CONTRACT CHANGE ORDER NO. _____
 SHEET _____ OF _____

SAS SUPERSTRUCTURE - CONDUIT AND CABLE TRAY PLAN

SAS SUPERSTRUCTURE GIRDER EASTBOUND LIGHTING AND ELECTRICAL SYSTEMS

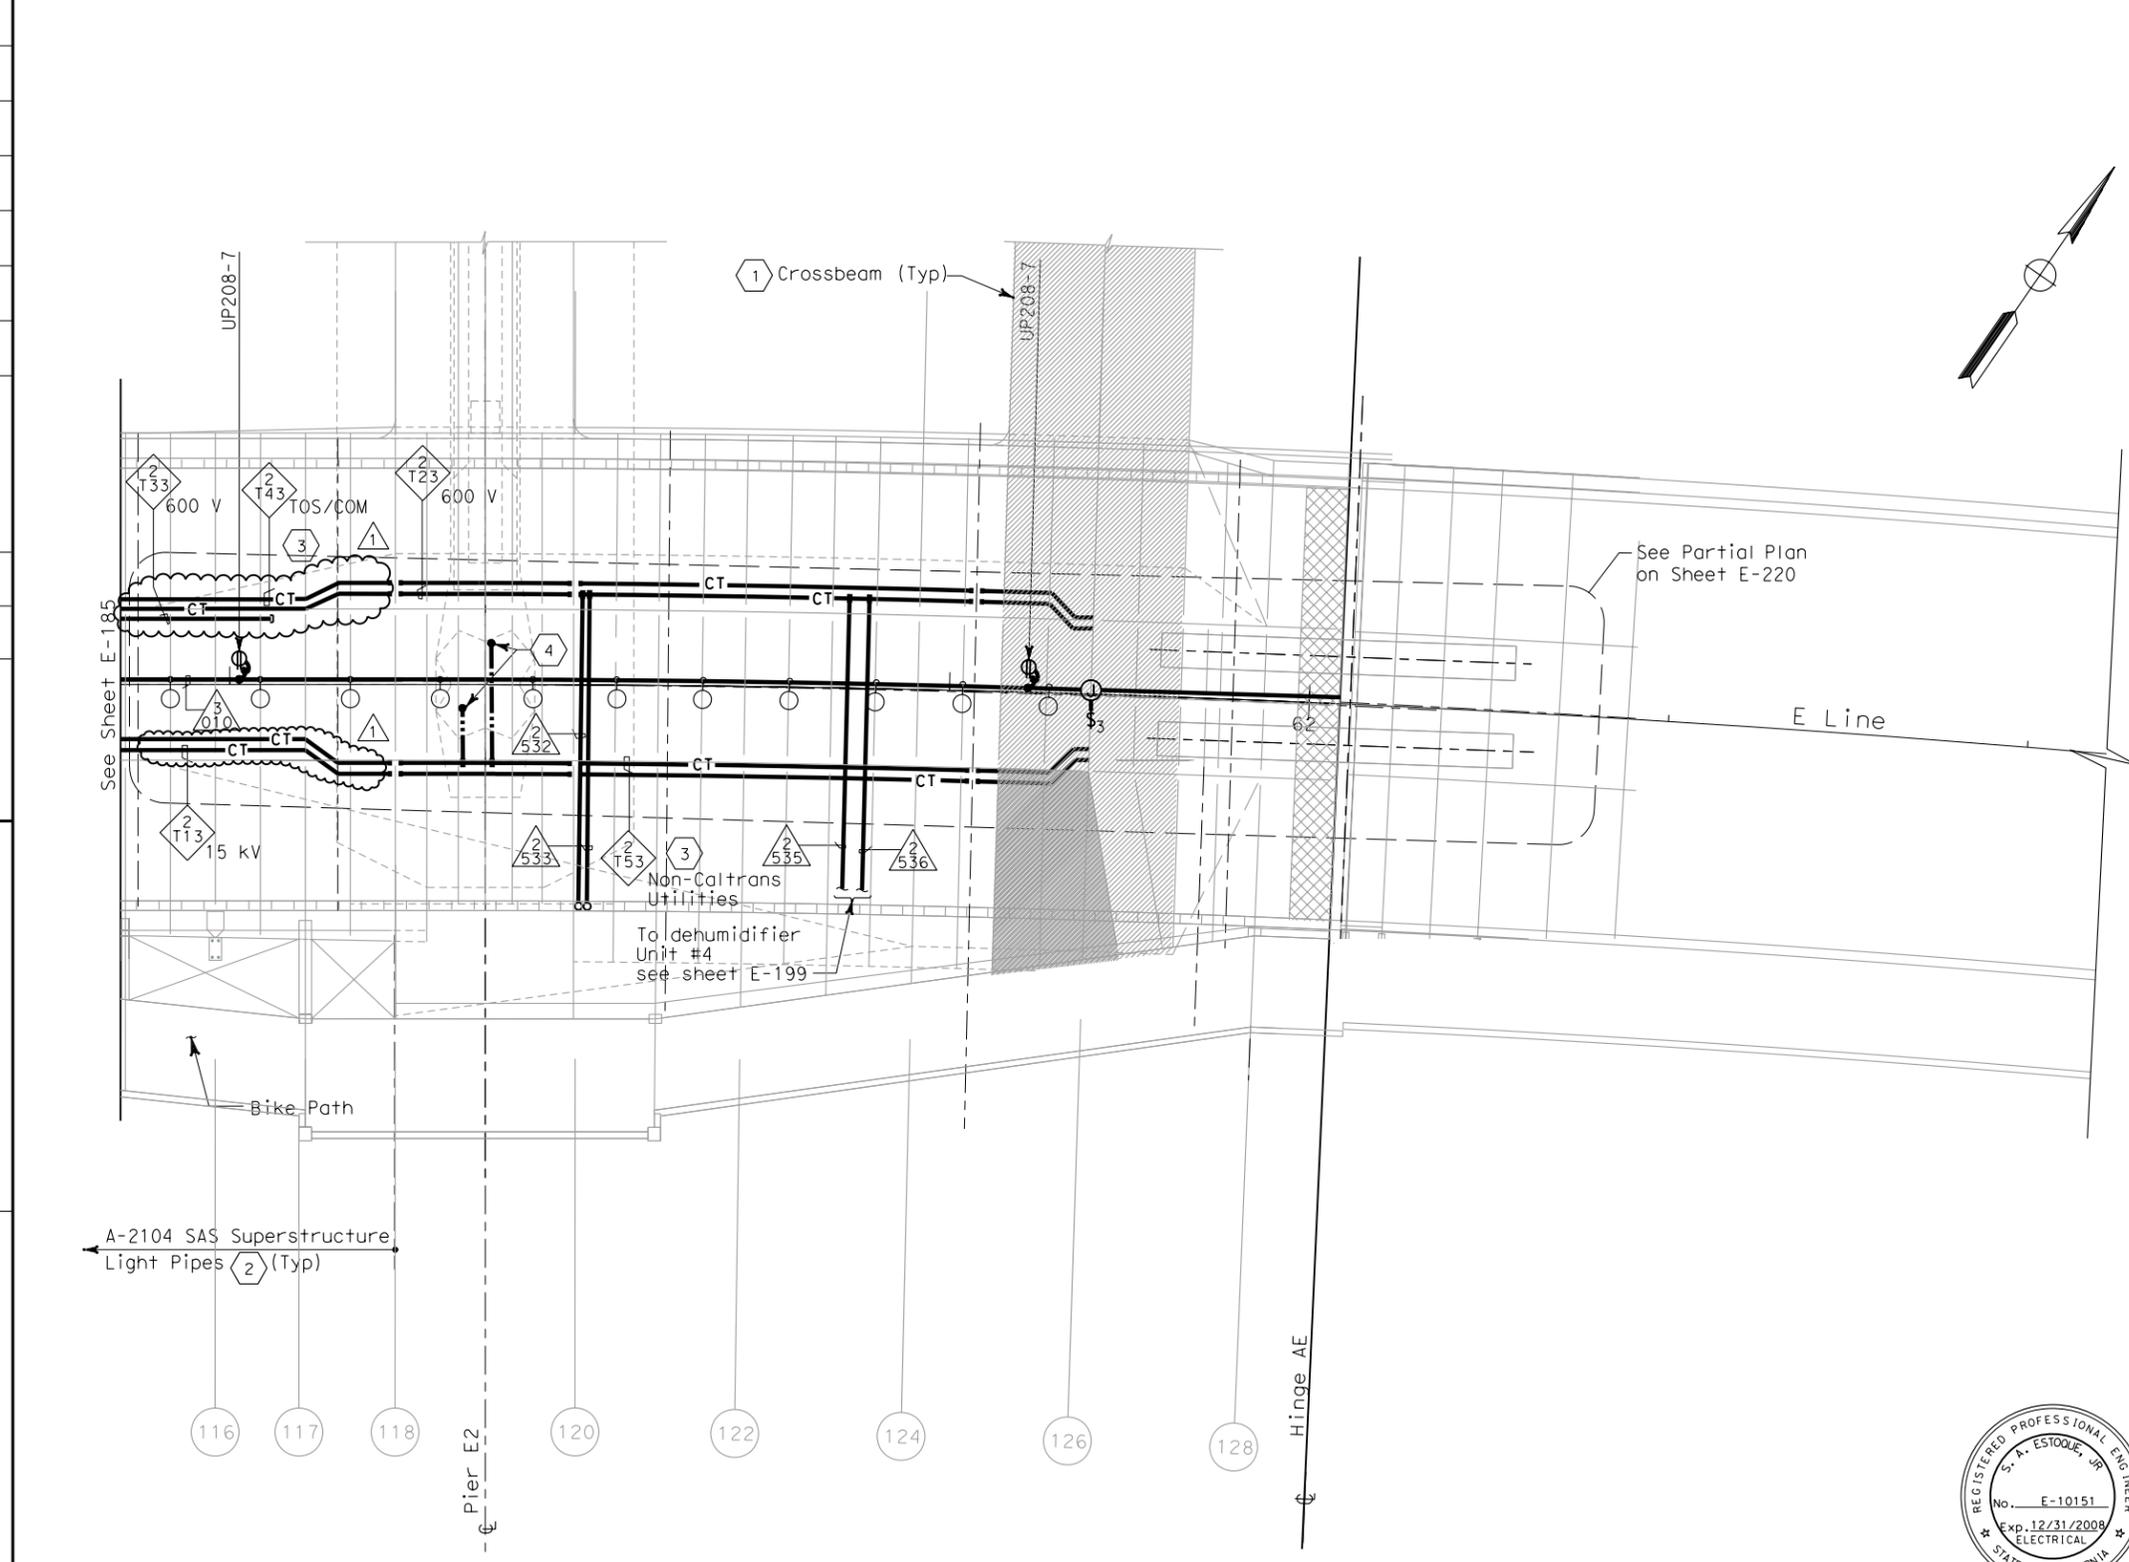
REQUEST FOR INFORMATION NOT ADDRESSED IN THIS CCO REMAIN IN FORCE					
△	02/25/08	CABLE TRAY CHANGES	JD	RG	4251
MARK	DATE	DESCRIPTIONS	BY	CH'D	CCO#
REVISIONS
